# UNITED STATES PATENT AND TRADEMARK OFFICE

APPLICATION NO.	FILING DATE	FIRST NAMED INVENTOR	ATTORNEY DOCKET NO.	CONFIRMATION NO.
10/667,644	09/22/2003	Hyun-Rok Cha	084017.22224	1116
26530	7590	04/26/2006	EXAMINER	
LADAS & PARRY LLP 224 SOUTH MICHIGAN AVENUE SUITE 1600 CHICAGO, IL 60604			CAZAN, LIVIUS RADU	
			ART UNIT	PAPER NUMBER
			3729

**Office Action Summary**

## **DETAILED ACTION**

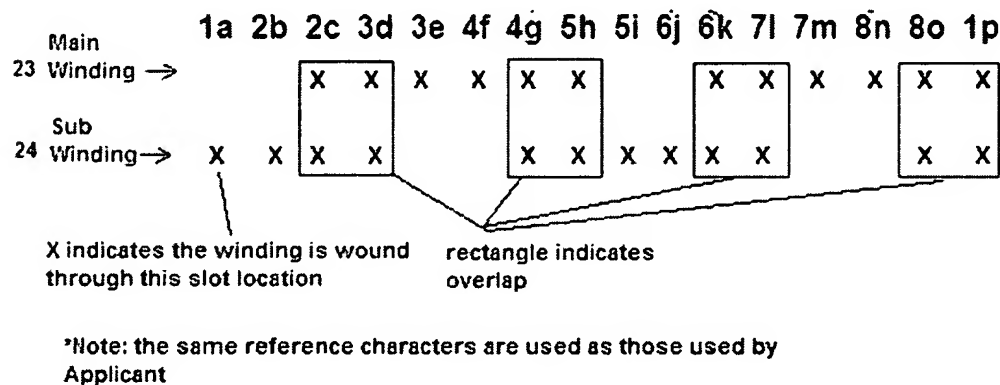
The Applicant is encouraged to carefully read the specification and correct any additional errors that may still be present in the specification. Furthermore, the specification (including the claims) should be amended so as to clarify the

location of overlaps. For example, with respect to the embodiment of Fig. 11, the phrase "wherein at the four (4) slots" (as on page 12, line 16) is very unclear. One reading the specification would understand that windings 23 and 24 overlap in four of the slots. A more accurate interpretation would be that they overlap on four of the stator teeth (transitions from slot 2 to slot 3; 4 to 5, 6 to 7, and 8 to 1), as can be seen in the following figure. The other embodiments should be corrected as well.

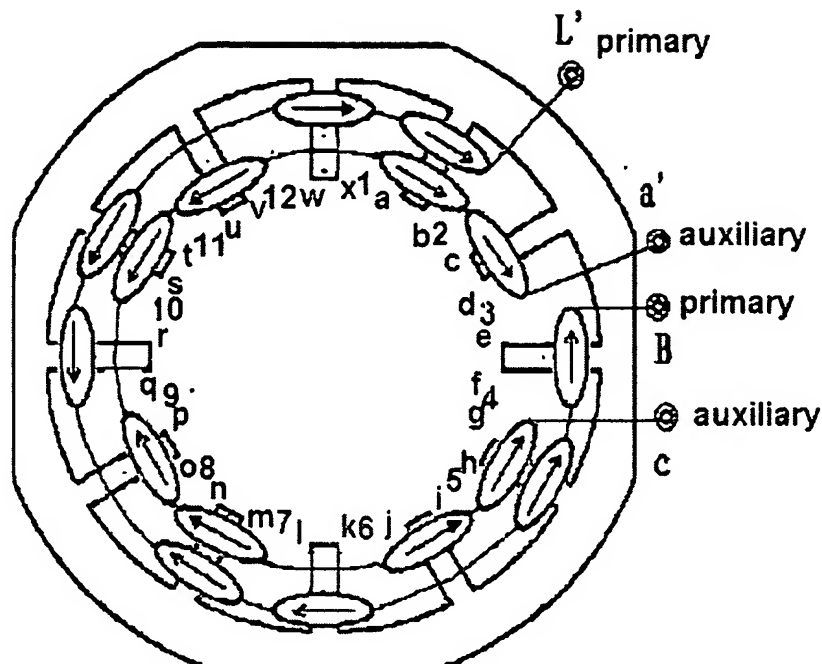
Regarding claims 1 and 2, Kenji et al. disclose winding a main winding (windings 7b, 7c, 7d, 7e, 7f, 7i, 7k, and 7l, and 7j in Fig. 2) and a sub winding (8a, 8c, 8d, 8f, 8g, 8i, 8j, 8l) through slots formed on a stator of a single phase induction motor, the main winding and the sub winding being wound with a regularity so that each is inserted into a predetermined slot and then is wound consecutively (i.e. without skipping any slots) through neighboring three (3) slots with reference to the initially entered slot, wherein at four stator slots, the main winding and the sub winding are overlapped. See the image below (based on Fig. 6).

The primary winding starts at slot 3 (3e) and is wound through the next three consecutive slots, i.e. 4f and 4g in slot 4, 5h in slot 5, and 6k in slot 6. The auxiliary winding starts at slot 4 (4g) and is wound through the next three consecutive slots, i.e. 5h and 5i in slot 5, 6j in slot 6, and 7m in slot 7. The two windings overlap on four of the stator teeth, i.e. the between 1a and 2b, the tooth between 4g and 5h, the tooth between 7m and 8n, and the tooth between 10s and 11t.

Regarding claims 3 and 4, Kenji et al. disclose inserting the main winding into a first slot 3 (3e) and is wound consecutively through seven other slots, i.e. slots 4 (f and 4g), 5 (5h), 6 (6k), 7 (7l and 7m), 8 (8n), 9 (9q), 10 (10r and 10s). The sub winding is inserted into a first slot 4 (4g), and is wound consecutively through seven other slots, i.e. slots 5 (5h and 5i), 6 (6j), 7 (7m), 8 (8n and 8o), 9 (9p), 10 (10s), and 11 (11t and 11u).

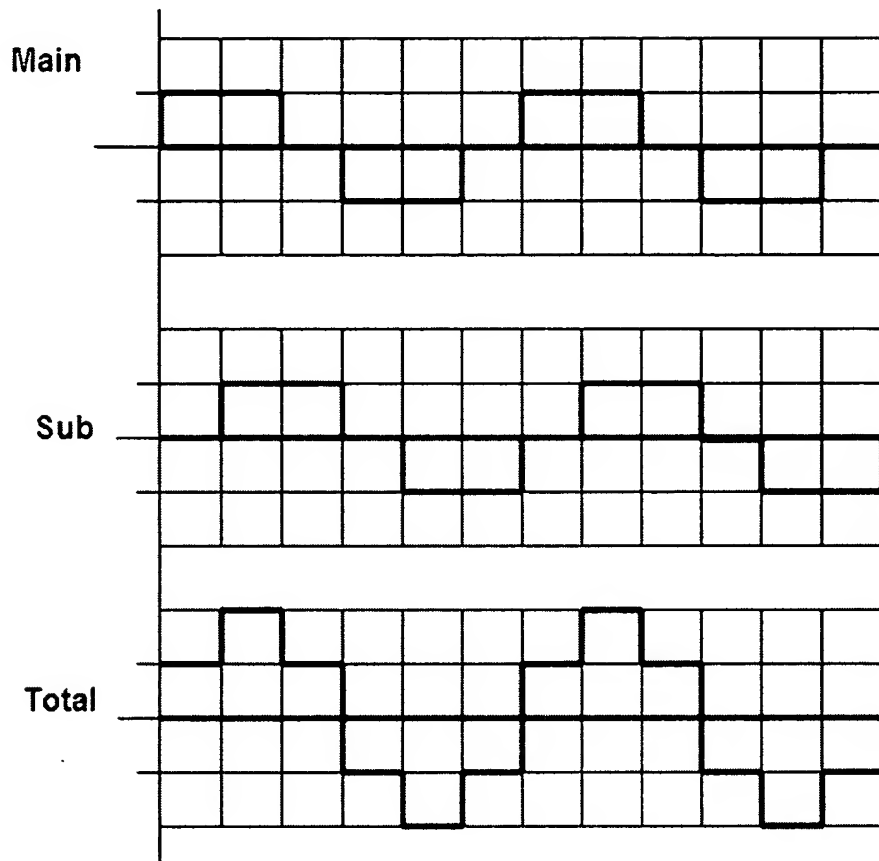
However, Kenji et al. disclose a winding arrangement which inherently results in a sinusoidal mmf waveform (see the image below).

“Main” illustrates a waveform produced by the main winding, “Sub” a waveform produced by the sub winding, and “Total” shows the net mmf waveform. As can be seen, the resultant waveform is sinusoidal, as in applicant’s invention.

At the time the invention was made, it would have been an obvious matter of design choice to a person of ordinary skill in the art to wind a stator core as in the invention claimed by the applicant because Applicant has not disclosed that winding the stator in the *particular* arrangement claimed in claim 3 provides an advantage, is useful for a particular purpose, or solves a stated problem that could not be solved by using a different winding pattern. Passing a winding through N slots before skipping a stator tooth, as opposed to say N+1 or N-1 affects the shape of the waveform, but maintains
